Review of Wilpinjong PIT 8 EXTENSION MODIFICATION BDAR

David C Paull
Qualitative
PO Box 67 Coonabarabran NSW
21 October 2025

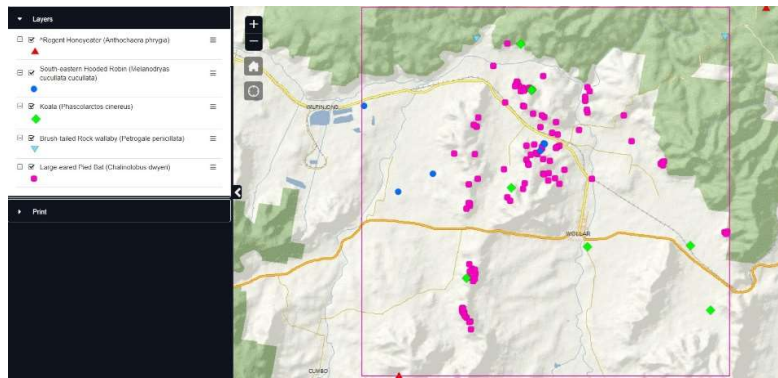
The non-grass species account for only eight species according to the data collected by the consultant, despite the contribution of non-grass species (measure of cover) being 23.5%. Only six plots were sampled in this community, while consistent with BAM requirements for survey intensity, the question remains, did other species occur outside the plots which did not register for a contribution due to

relatively low numbers (a less than 1%). While plots are important to determine cover and presence, establishing a comprehensive species list should also require random transect searches to establish a more reliable measure of diversity. This is important because grasslands are not of an even character in terms of slope, aspect and microhabitats. Despite this method being standard for most vegetation surveys in the past, this component seems not to have been undertaken for the Wilpinjong Modification. It would be fair to say that total plant diversity has not been adequately addressed in the BDAR. Below is the species richness summary contained in the BDAR.

BioNet records for affected species (accessed 6/10/25)

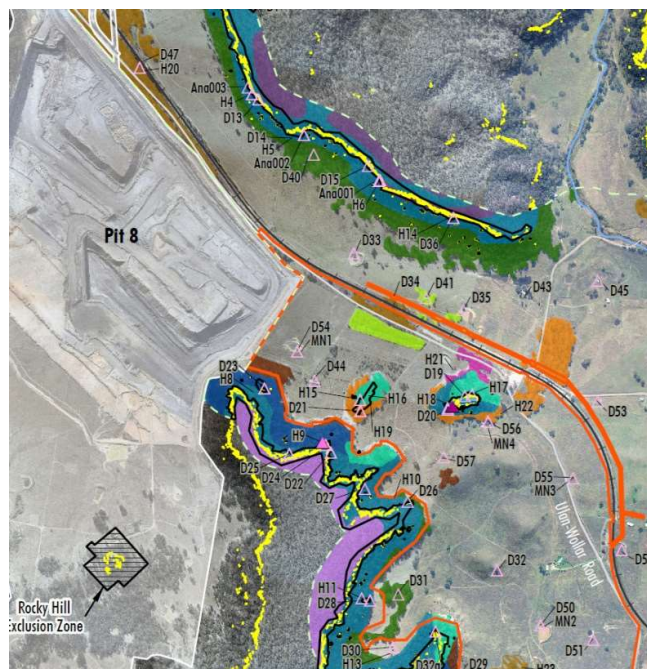
They found additional records north of the railway line and adjacent to the hilly terrain. Similar results were obtained for the Eastern Cave Bat. In addition, there are a large number of previous records of these species from the development footprint (BioNet figure).

Breeding sites are very specific structural requirements for these species, especially the Large-eared Pied Bat and even though areas of potential breeding habitat can be found extensively in the region, we do not know of any specific locations outside the development footprint. As the species credit guidelines say, any presence of potential habitat along with the capture of animals in breeding condition, then nearby breeding habitat should be assumed. Such a breeding individual was caught near the rocky outcrop to be removed, “single post-lactating female released from a harp trap returned to a crack in a cave in a large boulder on the large knoll in February 2023. Another individual was found roosting in this crack during an inspection in March 2023.”
